NOTIFICATION

#0009

SUBJECT: Static Longitudinal Stability – Permitted Removal of Elevator Centre Balance Weights.
Optional modification to be referred to as “Sling 4 TS*i* Optional Elevator Centre Balance Weight Removal Modification”

MODELS AFFECTED: Sling 4 TS*i* (All)

Figure 5 Trim arm clevis locking nut

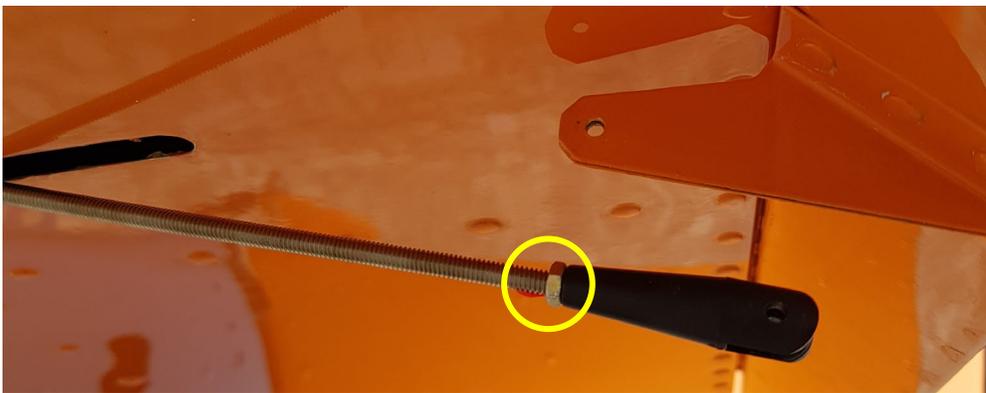
2. Remove the clevis/trim tab connecting pin.
3. Loosen the $\frac{1}{4}$ " nut, with the appropriate wrench, and turn the nut such that there is at least a 10mm gap between the nut and plastic clevis.

4. Turn the clevis a full 3 revolutions clockwise (inwards).
5. Tighten the locking nut against the clevis, without letting the clevis rotate.
6. Re-insert the clevis/trim tab control horn pin.
7. Insert a new split pin and secure in place.
